## **FAIRFIELDS RESUBDIVISION, PORTIONS OF LOTS 13 AND 14, BLOCK 2**

APPLICATION NUMBER 17 DATE February 17, 2005

APPLICANT Fairfields Re-Subdivision, Resubdivision of a Portion of Lots 13 and 14, Block 2

REQUEST Subdivision

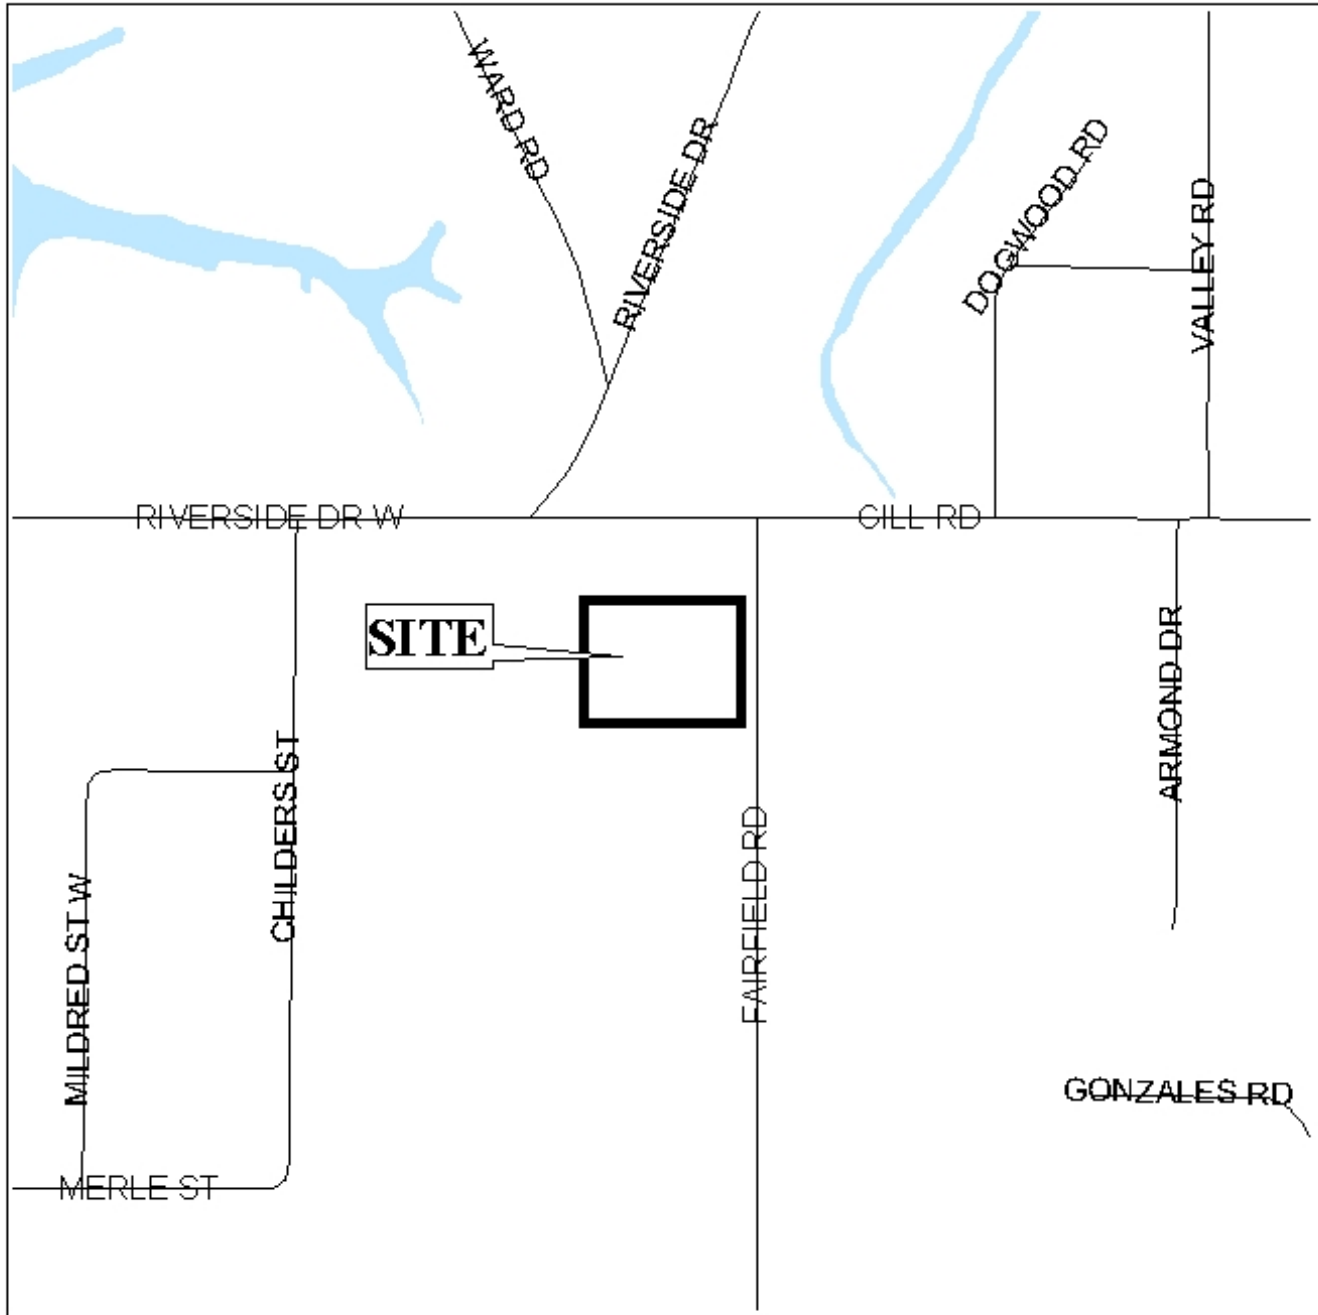
The plat illustrates the proposed 1.15  $\pm$  acre, 3 lot subdivision which is located on the west side of Fairfield Road, 120 feet  $\pm$  south of Gill Road, and is in Council District 4. The subdivision is served by public water and sanitary sewer.

The purpose of this application is to create a three-lot subdivision from a portion of two existing lots of record. As depicted on the Vicinity Map, the proposed subdivision does not include the full extent of the two existing lots.

The 25-foot minimum building setback line is not shown but would be required on the Final Plat, if approved.

The proposed subdivision will result three lots, each from 14,000 to 20,000  $\pm$  square feet in area, and would exceed the minimum size required in Section V.D.2. for properties with public water and sanitary sewer.

The proposed Lot 3, however, exceeds the width to depth ratio recommended in Section V.D.3. of the Subdivision Regulations. Furthermore the flag-shaped nature of proposed Lot 3 is uncharacteristic of other lots in the area and thus is not in conformance with Section V.D.1. of the Subdivision Regulations, which states: "*The size, width, depth, shape, and orientation of lots and the minimum building setbacks lines shall be appropriate to the location of the subdivision and the type of development and use contemplated.*" Approval of this subdivision request could result in future requests for subdivisions with flag-shaped lots.

Construction of a new residence on the proposed Lot 3 could potentially result in privacy conflicts between residents of the existing single-family home located on the proposed Lot 2 and future residents living on the proposed Lot 1.

Finally, the creation of the proposed Lot 3 would result in a lot with an existing accessory structure without a primary dwelling. Accessory structures are not permitted in R-1 zoned areas without an associated primary structure (a residence) on the same property.

Based upon the proceeding, this subdivision is recommended for denial for the following reasons: 1) the plat does not include the overall existing lots of record; 2) the flag-shaped nature of the proposed Lot 3 is uncharacteristic of other lots in the area and thus does not comply with Section V.D.1. of the Subdivision Regulations; and 3) the proposed Lot 3 does not conform to Section V.D.3.
